DESIGN <i>PH</i>	DRAWN BY <i>PH</i>	DART AEROSPACE USA, INC. PORT HADLOCK, WA	
CHECKED <i>[Signature]</i>	APPROVED <i>[Signature]</i>	DRAWING NO. DSI 9343	REV. A SHEET 1 OF 1
DATE 06.07.12		TITLE D350-636-011/-012 SPACER	SCALE NTS
A	06.07.12	NEW ISSUE

DART SERVICE INSTRUCTION

TO AMEND DRAWING IIN-D350-636 REV. D

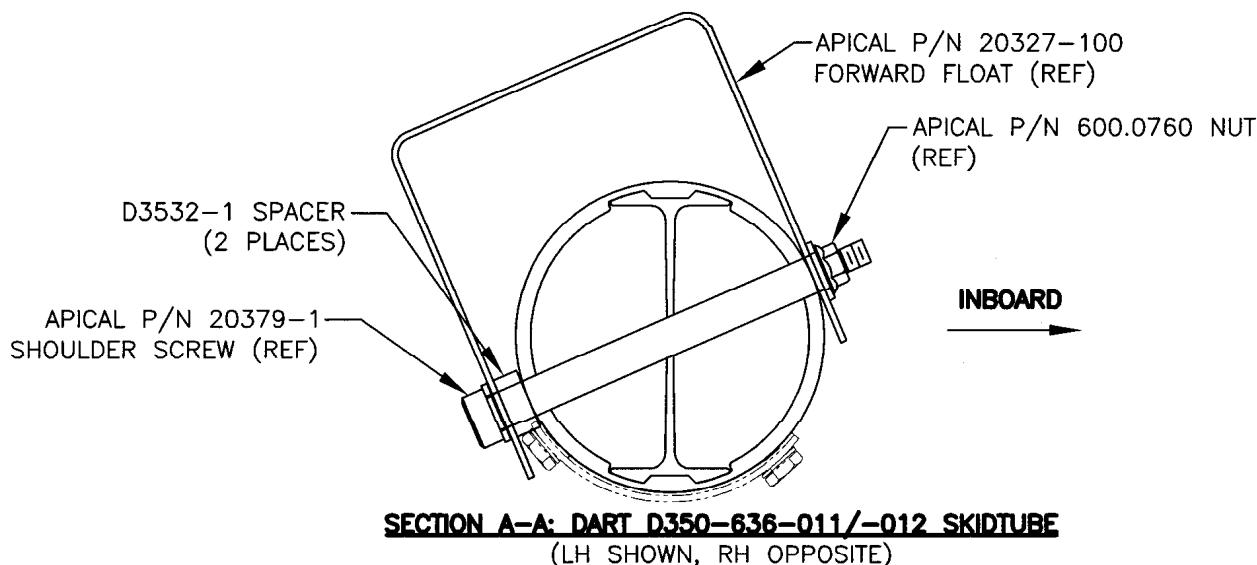
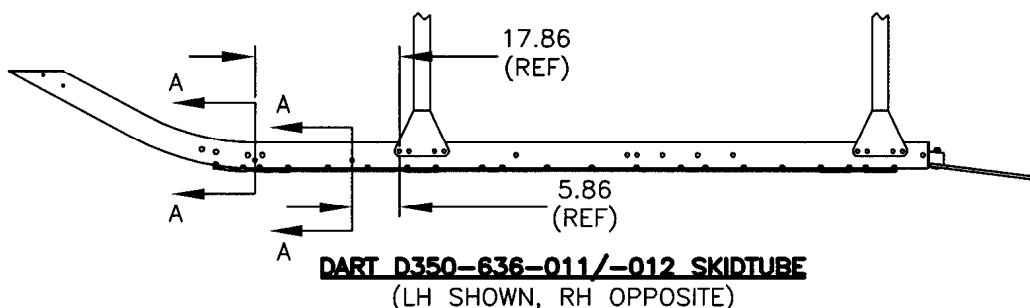
WHEN INSTALLING THE APICAL P/N 20327-100 FWD FLOATS ONTO THE DART D350-636-011/-012 SKIDTUBES, INSTALL THE DART D3532-1 SPACER AS SHOWN IN SECTION A-A TO ALLOW CLEARANCE FROM THE FWD WEARPLATES.

ADD THE FOLLOWING PARTS TO THE PARTS LIST ON PAGE 10 AND 11 OF IIN-D350-636 REV D:

Item	Qty -011	Qty -012	Qty -103	Qty -104	Part Number	Description
	X				D350-636-011	SKIDTUBE INSTALLATION, LH, STD AERAZUR/APICAL CYLINDRICAL FLOAT COMPATIBLE
		X			D350-636-012	SKIDTUBE INSTALLATION, RH, STD AERAZUR/APICAL CYLINDRICAL FLOAT COMPATIBLE
			X		D350-636-103	APICAL FLOAT CONVERSION KIT, LH
				X	D350-636-104	APICAL FLOAT CONVERSION KIT, RH
50	2	2	2	2	D3532-1	SPACER
